Subject: License No. SUB-1010, Docket No. ~~040-08027~~
Reclamation Plan Acceptance Review, Request for Additional
Information

ENCLOSURE 1
Sequoyah Fuels Corporation
Reclamation Plan Acceptance Review
Request for Additional Information

SFC Responses to Request for Additional Information
August 29, 2003

Title: TYPICAL CROSS SECTION ON EAST SIDE OF DISPOSAL CELL	
PREPARED BY: SFC	Filename: SFC0090B
Reviewed by: CH	Figure No.3-2
Date: 08/26/2003

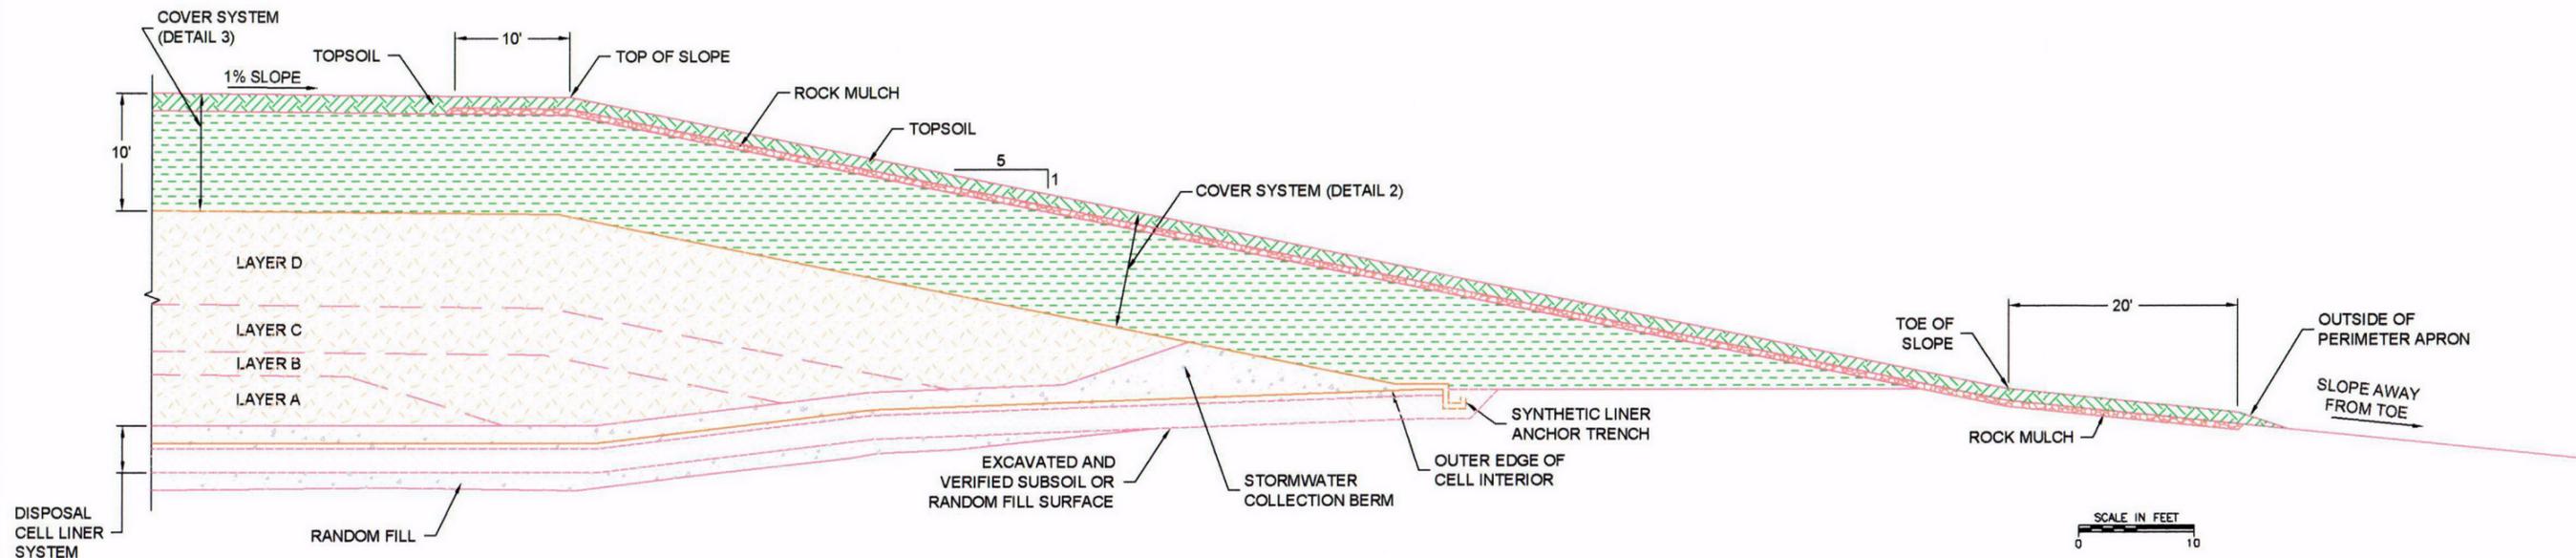
GW1. Liner configuration: According to figure 3-2, the liner will only partially underlay the tailings and will not have angled sides to the impoundment. This is not adequate from a groundwater protection perspective. In addition, the application has statements such as "if the clay liner is used." In order to review the design, staff must know what the liner material will be.

Per 10 CFR Part 40, Appendix A, Criterion 5A(2) the liner must be "installed to cover all surrounding earth likely to be in contact with the wastes or leachate." Per Criterion 5A(1) the liner must be "designed, constructed, and installed to prevent any migration of wastes out of the impoundment to the adjacent subsurface soil, groundwater, or surface water at any time during the active life (including the closure period) of the impoundment."

Since the original plan was proposed, ongoing testing by SFC has clarified the dewatering and treatment strategy for the sludges. In order to provide more flexibility in disposal cell operation and water management, SFC has modified the overall containment concept for the disposal cell. This concept incorporates a multilayered liner system covering the entire disposal cell base and a multilayered cover system over the disposed materials. The liner system and cover system are described below.

The liner system will include (from bottom to top): (1) compacted random fill (of variable thickness) above the excavated soil surface to achieve desired slopes, (2) a 24-inch thick layer of compacted clay (from on-site sources), (3) a 6-inch thick layer of sand (from off-site sources) as a bedding layer, (4) a synthetic liner, (5) an 18-inch thick layer of sand (from off-site sources) as a protective layer and

drainage layer above the synthetic liner. The two sand layers will include a grid of slotted pipe sloped to drain to two external sumps at the southwest corner of the disposal cell. The sumps will serve as monitoring locations for leachate collection (above the synthetic liner) and leak detection (beneath the synthetic liner).

The cover system will include (from bottom to top): (1) a compacted and smoothed disposed material surface to provide a bedding layer, (2) a synthetic liner, (3) a 1.5-foot thick layer of cover soils or sand (from on-site or off-site sources) as a protective layer and drainage layer above the synthetic liner, (4) a 7-foot thick layer of cover soils (from on-site sources), and a 1.5-foot thick layer of topsoil and erosion protection material. The upper 1.5-foot thick layer will consist of entirely topsoil (from on-site sources) on the top surface of the disposal cell, and a 1.0-foot thick layer of topsoil above a 0.5-foot thick layer of rock mulch (from off-site sources) on the side slopes of the disposal cell.

The synthetic liner to be used in the disposal cell liner system and cover system will most likely be a 60-mil thickness high-density polyethylene that is installed, seamed, and tested according to current liner construction practices. The two synthetic liners will be anchored together along the perimeter of the disposal cell to form a complete geomembrane system around the disposed materials. Long-term containment will be provided by the cover soils and clay liner.
